DEVELOPMENT APPLICATION ASSESSMENT REPORT

Application Number:	DA2022/0347
----------------------------	-------------

Responsible Officer:	Kye Miles
Land to be developed (Address):	Lot 108 DP 24360, 3 Lumeah Avenue ELANORA HEIGHTS NSW 2101
Proposed Development:	Alterations and additions to a dwelling house
Zoning:	C4 Environmental Living
Development Permissible:	Yes
Existing Use Rights:	No
Consent Authority:	Northern Beaches Council
Land and Environment Court Action:	No
Owner:	Jonathon Francis Ducker Laura Madeline Ducker
Applicant:	Anthony O'Brien

Figure 1. Envelope encroachment diagrams

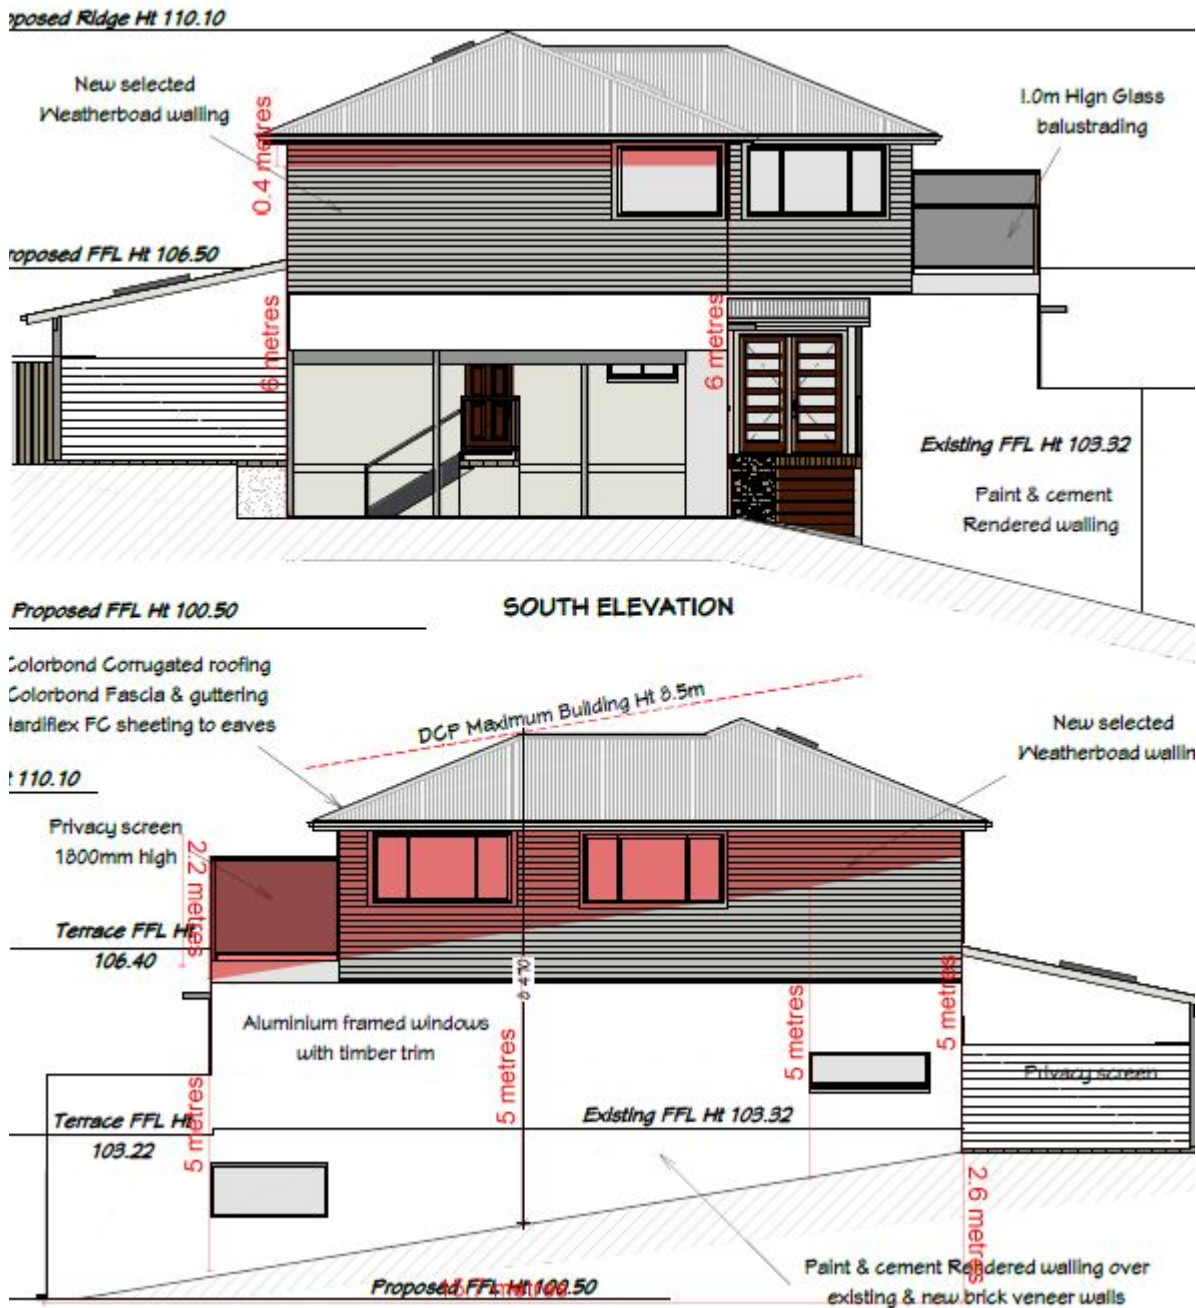
Clause D12.8 of the P 21 DCP prescribes a 3.5m side building envelope projecting at 45 degrees from the side boundaries.

The proposed first floor addition encroaches the building envelope on both side boundaries, as displayed in red below.

Notwithstanding the encroachments to the building envelope, the proposal is deemed to achieve the desired future character of the Elanora locality.

The proposed addition will generally remain below the surrounding canopy trees that define the natural environment. The proposed dwelling provides a compliant building height, which is compatible with the surrounding built form. In addition, the works will be substantially set back from the street and reasonably screened by existing and proposed vegetation. In this regard, the proposal's design is of a building scale and density that is compatible with the surrounding natural environment.

The proposed addition has maintained the subject dwelling's setbacks and is adequately designed to respond to the spatial characteristics of the subject site and the surrounding area. Additionally, the proposal involves minimal excavation due to being constructed over the existing footprint.

The proposal incorporates various materials, fenestration and open balconies to provide visual breaks along both elevation. In addition, the proposed landscape design is considered to enhance the site's natural features, through minimising the visual impact of the built form, such that it is secondary to landscaping and vegetation. Overall, the proportions of the encroaching elements are not considered to be unreasonably scaled or bulky.

Having regard to the above assessment, it is concluded that the proposed development is consistent with the relevant objectives of PLEP 2014 / P21DCP and the objectives specified in s1.3 of the Environmental Planning and Assessment Act, 1979. Accordingly, this assessment finds that the proposal is supported, in this particular circumstance.
